Permit Application Review Report
Date: 10/21/2026

Project Name: Harmony Estates 4th Addition

Project PAN: P-21-161

Recommendation: Approve with 2 Conditions and 4 Stipulations

Figure 3a: Soils & Erosion Control

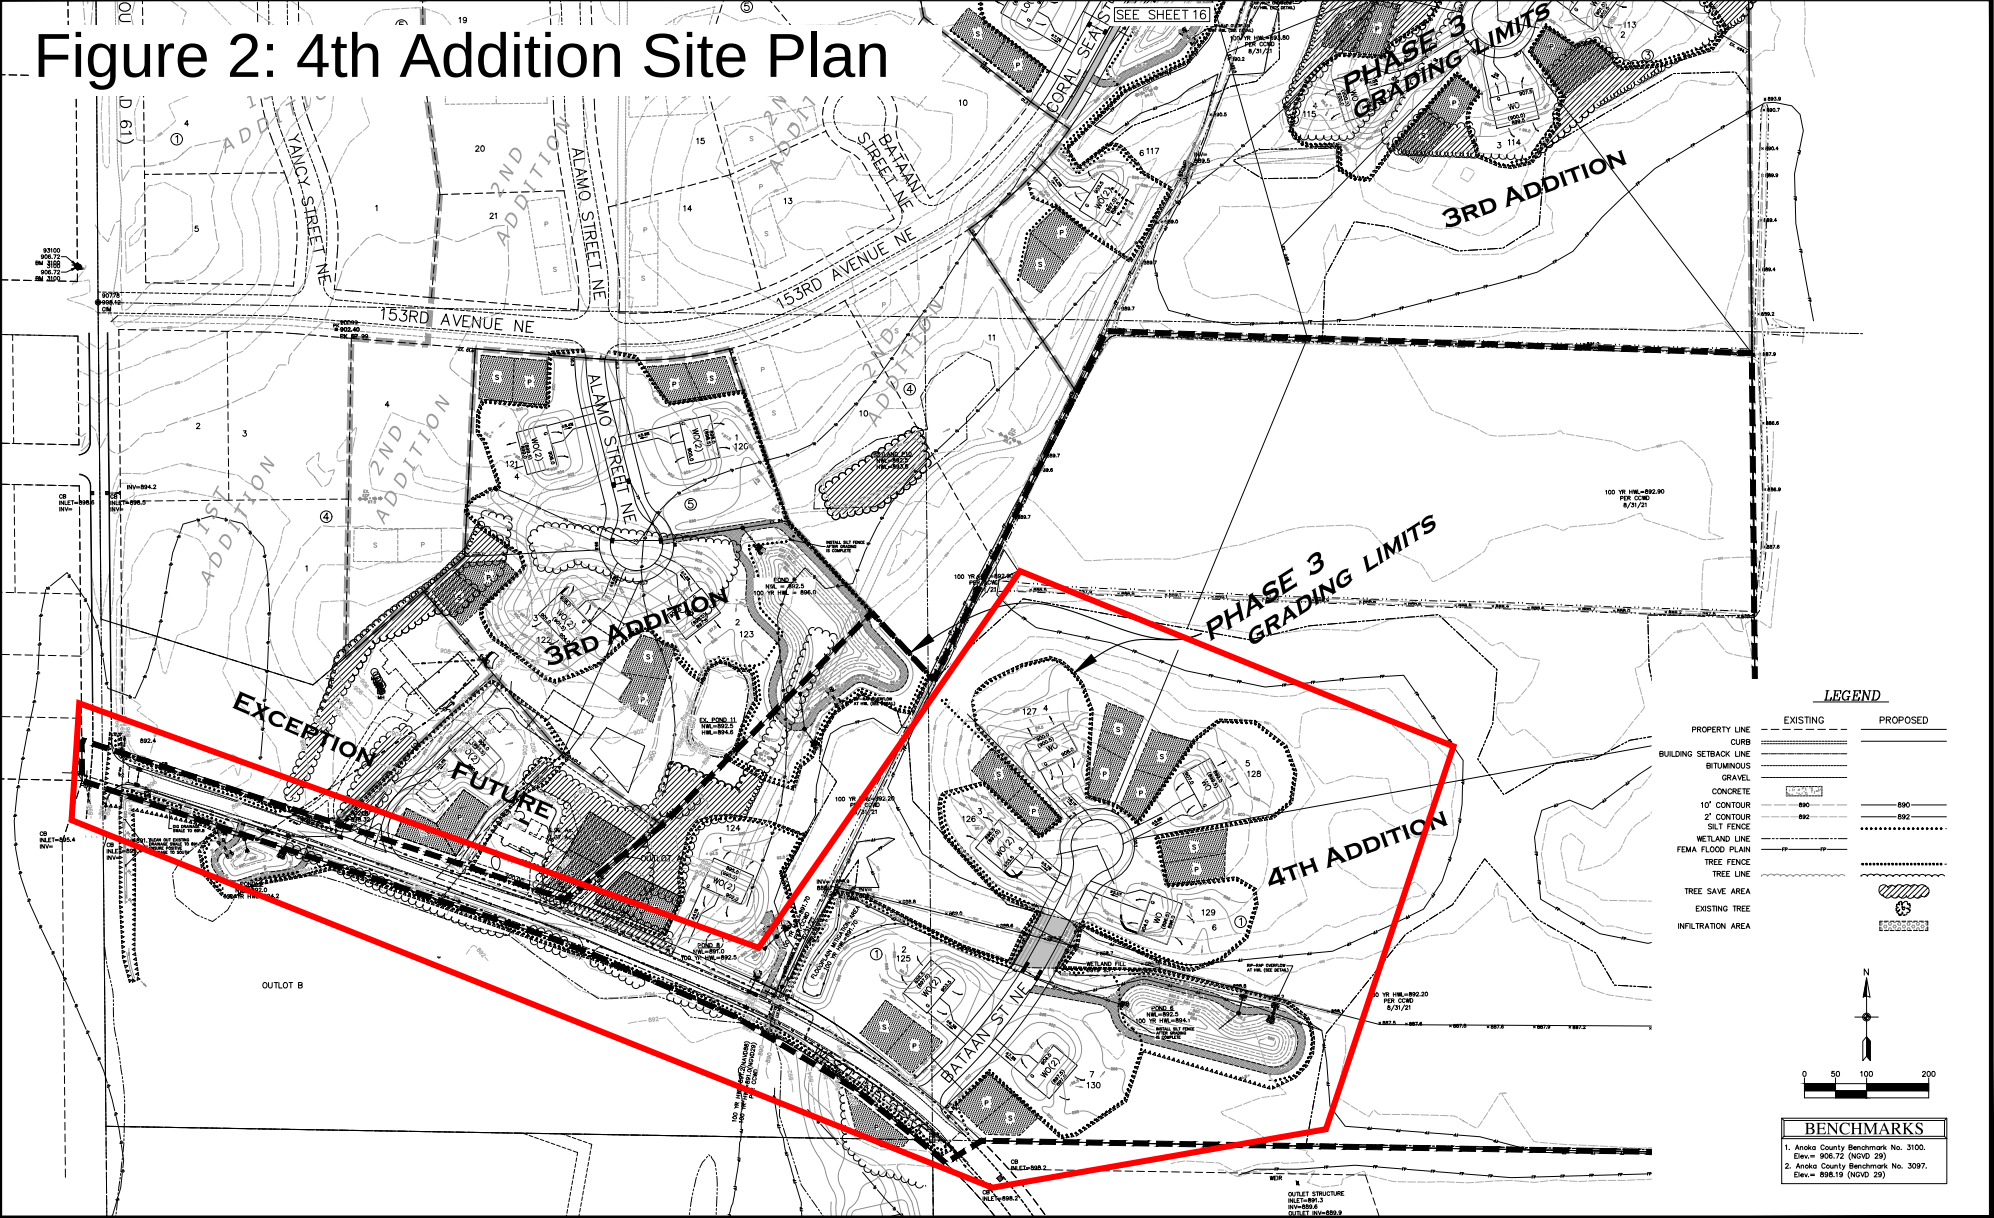
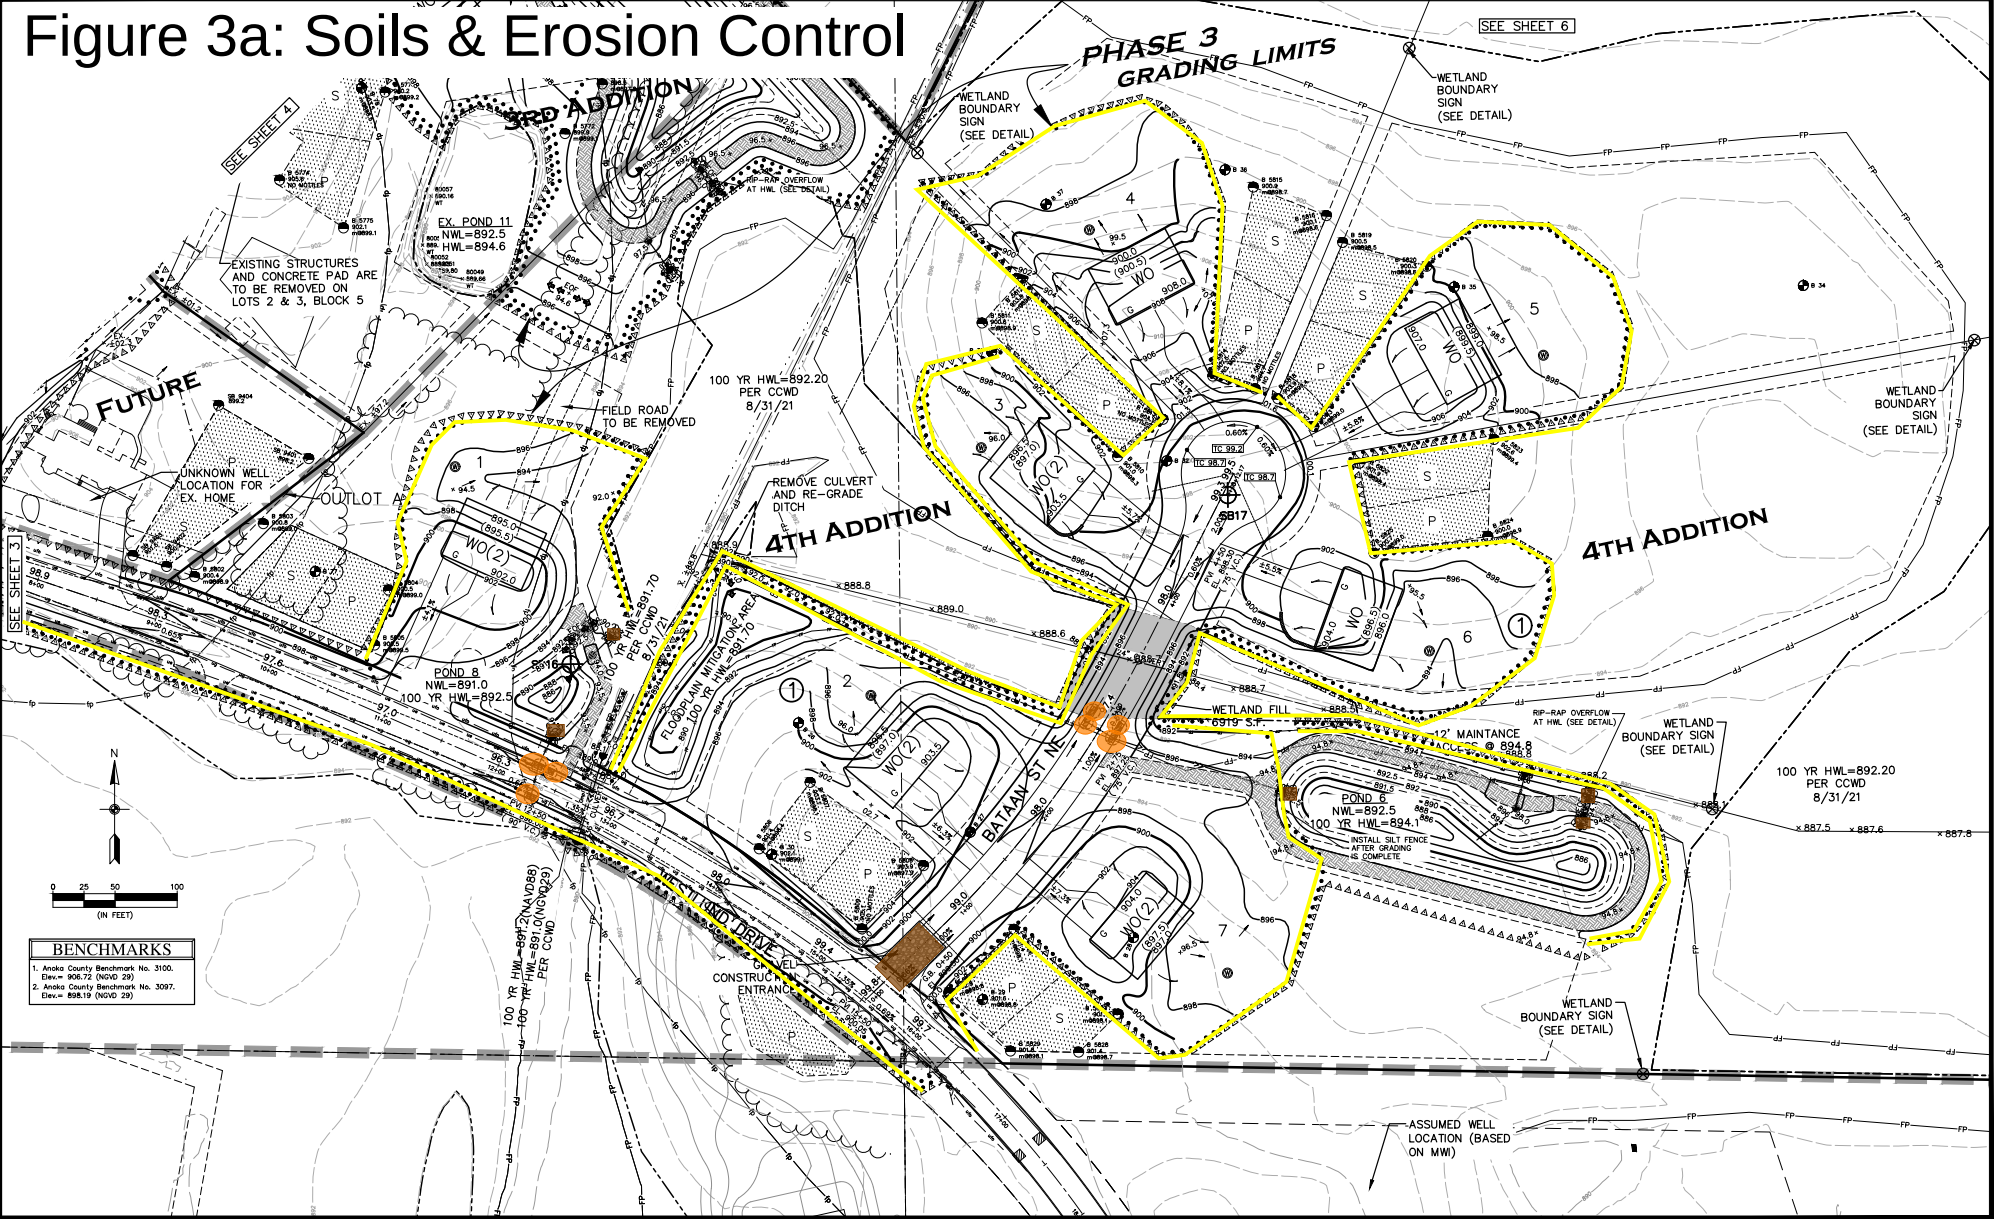
The proposed project drains to County Ditch 11. The soils affected by the project includes Zimmerman and Rifle and have a soil erodibility factor of 0.15 or greater. Disturbed areas are not proposed to be stabilized within 24 hours, as required. The proposed erosion and sediment control plan includes redundant perimeter control, inlet protection, and stabilized construction entrance. The erosion control plan does not meet District requirements because soils and soil stockpiles are not proposed to be stabilized within 24 hours of inactivity. The site does require an NPDES permit. See attached Figure 3: Soils & Erosion Control.

2. Update to SWPPP to stabilize soils and soil stockpiles within 24 hours of inactivity.

Figure 4: Wetland Fill & Floodplain Mitigation

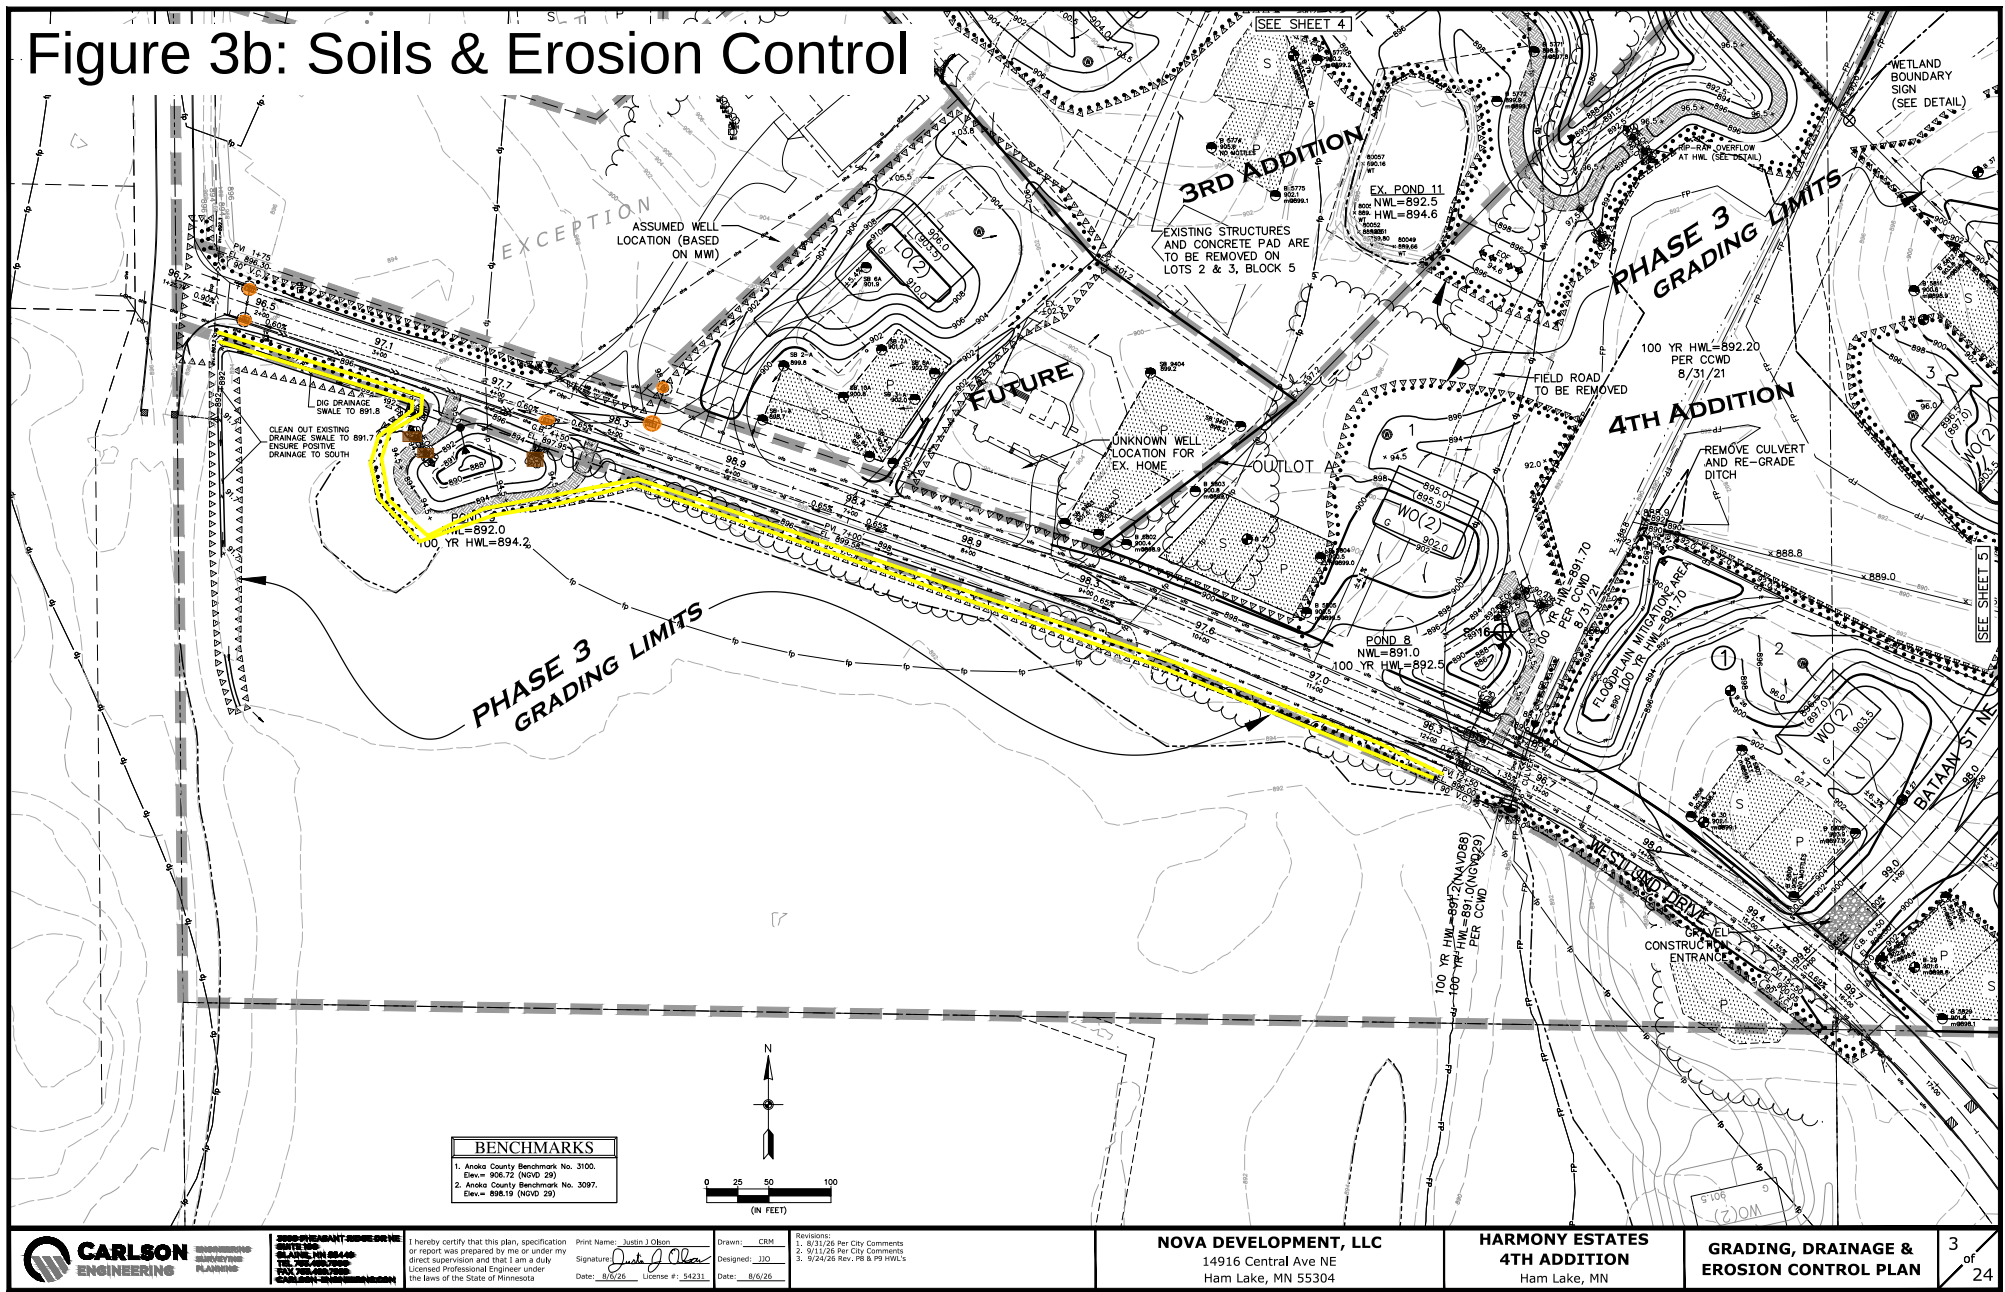
Impact replacement has been mitigated through the purchase of wetland bank credits from bank 1762. Bank 1762 is within the required bank service area (BSA 7). The Notice of Decision was issued on 03/27/2025. See attached Figure 4: Wetland Impacts.

The regulatory floodplain elevation is 893.4 ft NAVD 88. The application proposes the placement of 24,476 cubic yards of fill within the floodplain. Compensatory storage is required. The proposed project provides 48,802 cubic yards of compensatory storage, which exceeds the required 1:1 ratio and is within the relevant reach.

The culvert is being provided in-kind and adequate compensatory storage is being provided which shows that the embankment can pass the 100-year flood without increasing the elevation of the 100-year flood profile or creating excessive velocities and equivalent hydraulic capacity has been provided. See Figure 4: Floodplain Mitigation.

1. Submittal of grading as-builts for the project to confirm adequate floodplain compensatory storage has been provided.
2. The applicant must apply for coverage under the Minnesota Pollution Control Agency's
